Palo Verde Nuclear
Generating Station

**Subject: Palo Verde Nuclear Generating Station (PVNGS)
Units 1, 2, and 3
Docket Nos. STN 50-528/529/530
Proposed Amendment for Administrative Changes to
Technical Specification Figure 3.5.5-1, "Minimum Required
RWT Volume"**

**Proposed Amendment to PVNGS Unit 1, 2 and 3
Technical Specification Figure 3.5.5-1**

FIGURE 3.5.5-1
Minimum Required RWT Volume

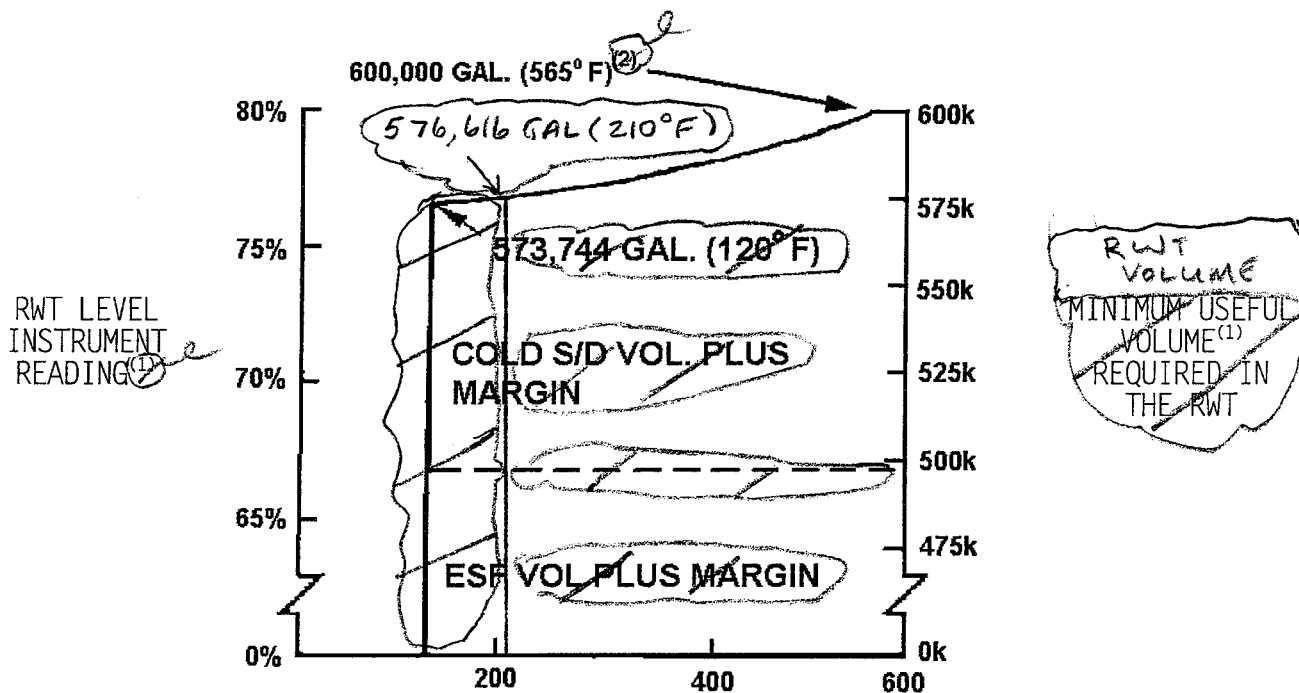
The proposed administrative TS amendment would revise TS Figure 3.5.5-1, "Minimum Required RWT Volume," to (1) relocate design bases information (but not the TS limits) to the TS Bases, (2) truncate the lower end of the RWT limit curve at 210°F, (3) re-title the right ordinate from "minimum useful volume in the RWT" to "RWT volume," and (4) delete the footnotes. The design bases information to be relocated are the portions of RWT volume that are shown for engineered safety features (ESF) volume (plus margin) and for cold shutdown volume (plus margin). These proposed changes are shown on a marked-up copy and a re-typed copy of Figure 3.5.5-1 in Sections G and H of this Enclosure.

The proposed change to truncate the RWT limit curve in Figure 3.5.5-1 to the lowest average RCS temperature of 210°F would be a human-factors enhancement. Since this figure is applicable only in modes 1, 2, 3, and 4, the lowest RCS temperature at which it is applicable is 210°F. This truncation would eliminate any potential confusion caused by this figure showing limits for operating conditions outside the modes in which this figure is applicable.

The proposed editorial change to re-title the right ordinate of the graph in Figure 3.5.5-1 from "minimum useful volume in the RWT" to "RWT volume" would make the graph consistent with the figure title and the RWT design bases.

The proposed editorial change to delete the footnotes from Figure 3.5.5-1 would eliminate unnecessary or redundant information from the figure. Footnote 1 is not necessary because it provides no useful information to the plant operators who ensure compliance within the RWT limits of Figure 3.5.5-1. Footnote 2 is redundant to the information provided in the figure, and provides no additional useful information to the plant operators.

G. Marked-up Technical Specification Page 3.5.5-3

(1) The tank level and volume shown are the useful level and volume above that in the tank which is required for vortex considerations.

(2) When average RCS temperature is $> 565^{\circ}\text{F}$, the minimum useful volume required in the RWT is 600,000 gallons.

FIGURE 3.5.5-1
Minimum Required RWT Volume

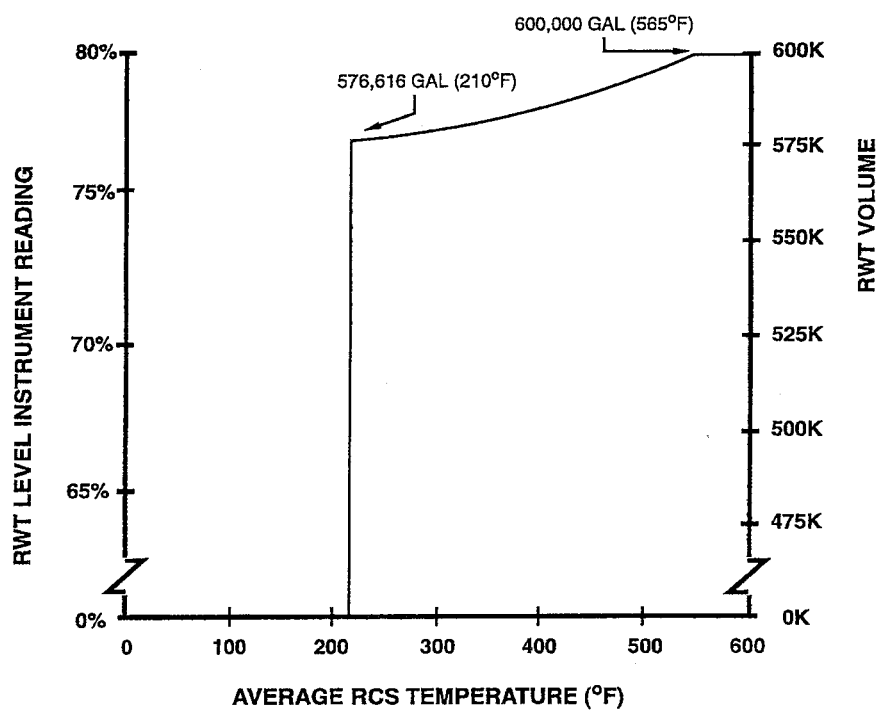
This proposed administrative TS amendment would revise TS Figure 3.5.5-1, "Minimum Required RWT Volume," to (1) relocate design bases information (but not the TS limits) to the TS Bases, (2) truncate the lower end of the RWT limit curve at 210°F, (3) re-title the right ordinate "minimum useful volume in the RWT" to "RWT volume," and (4) delete the footnotes.

H. Retyped Technical Specification Page 3.5.5-3
